PPPL ENGINEERING CHANGE NOTICE (ECN) ECN # 5140

COGNIZANT INDIVIDUAL: Dave Williamson	
ECN TITLE: Changes to Modular Coil Lead Area Design	
ASSOCIATED ECP: None	
CC/WP/Job: 9450-1***-1451	AREA OR PROJECT: NCSX

The purpose of these lead area design changes is to mitigate technical risks that have come to light in the course of testing the C1 Modular Coil. The following changes are proposed:

Figure 1

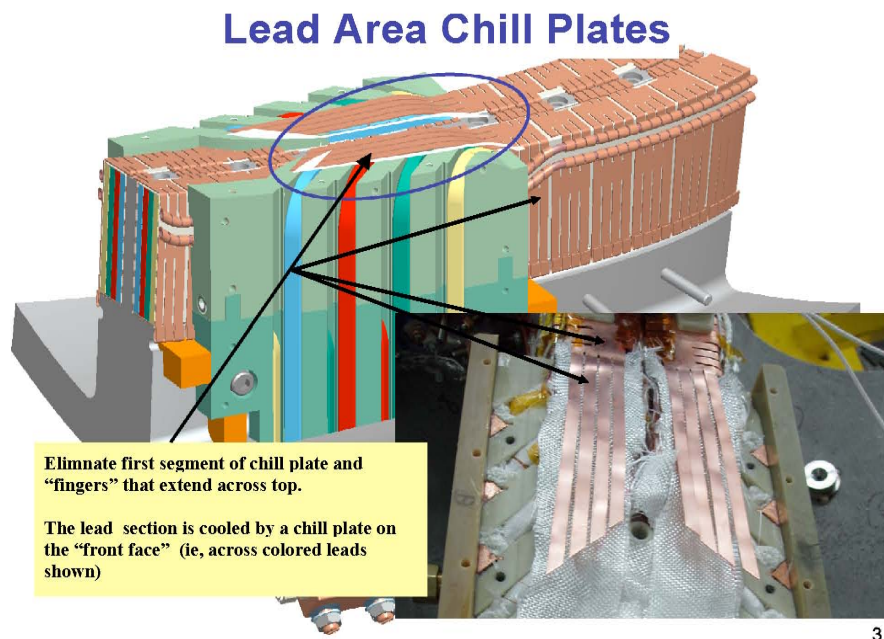
- On the top chill plate (the one with the long fingers that extend parallel to the coil) – cut off the fingers and eliminate the chill plate. **(See Figure 1)**. *This change will be implemented for the C3 and follow-on coils.*

Figure 3

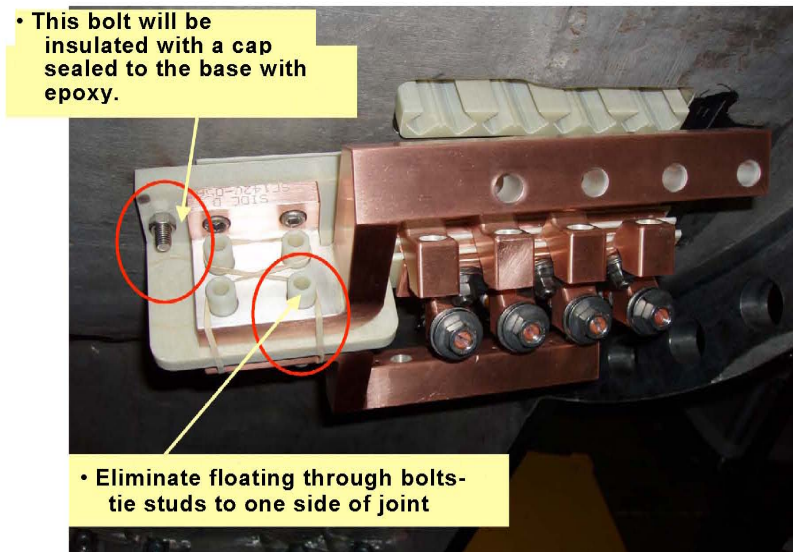
- For the power bus tie-in area, cap the attachment bolt with an epoxy seal to mitigate a potentially short tracking path.. **(See Figure 3L)**. *This should be implemented on all coils.*

- Presently the four bolts that connect the power bus are floating which is an undesirable condition **(See Figure 3R)** - connect them to one side by eliminating the insulating washers on the other side. *This should be implemented on all coils.*

Figure 4
Improve Tracking Distance

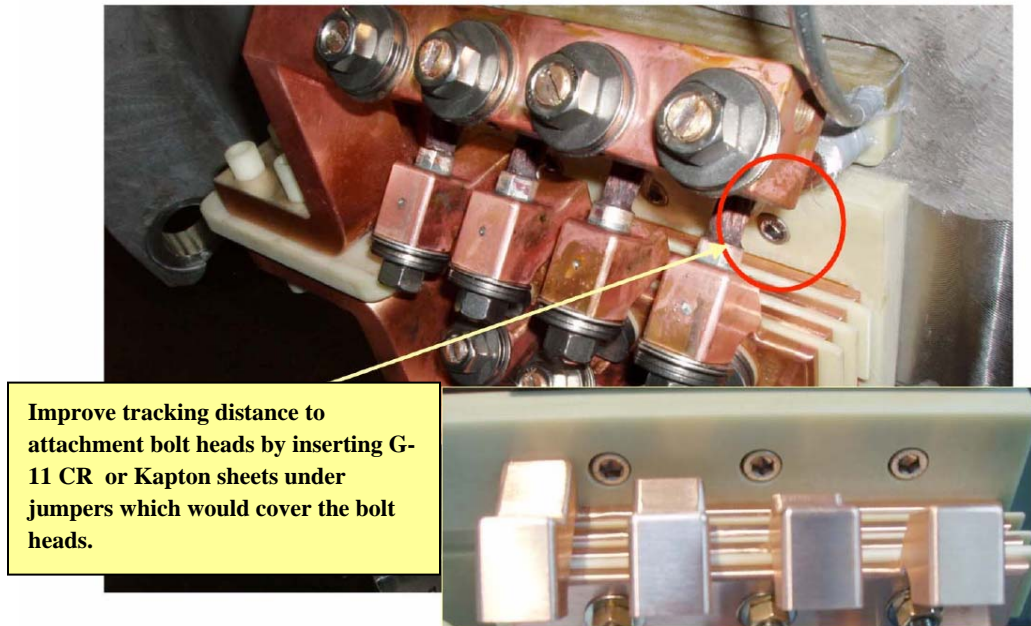
- The bolts that attach the G-11 base plate underneath the jumper stack – put a cover (Kapton or thin G-11 sheet) to increase the tracking distance. **(See Figure 4)**. *This should be implemented on all coils.*

Figure 5

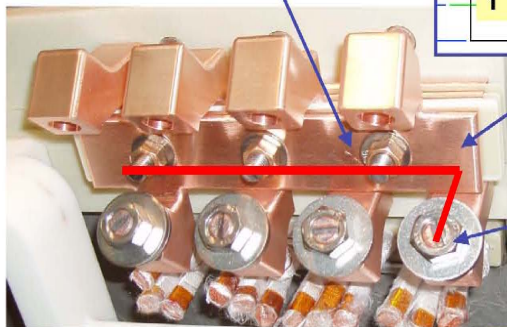
- For the three studs that bolt the stack of jumper plates together that are isolated – electrically tie them to one of the jumpers. **(See Figure 5)**. Also add an insulating “plug” at the base of the hole in the G-11 base plate to reduce the risk of the studs penetrating the G-11 backing sheet to the winding form. *This should be implemented on all coils.*

- Link the three jumper studs to the bottom jumper using
- [1] G-11cr insulator and
- [2] copper plate

The "L" shaped copper plate [2] will be connected to this point.

NOTE: Part [2] as shown is before it was decided to modify it to connect directly to this point rather than via a separate lug and wire.
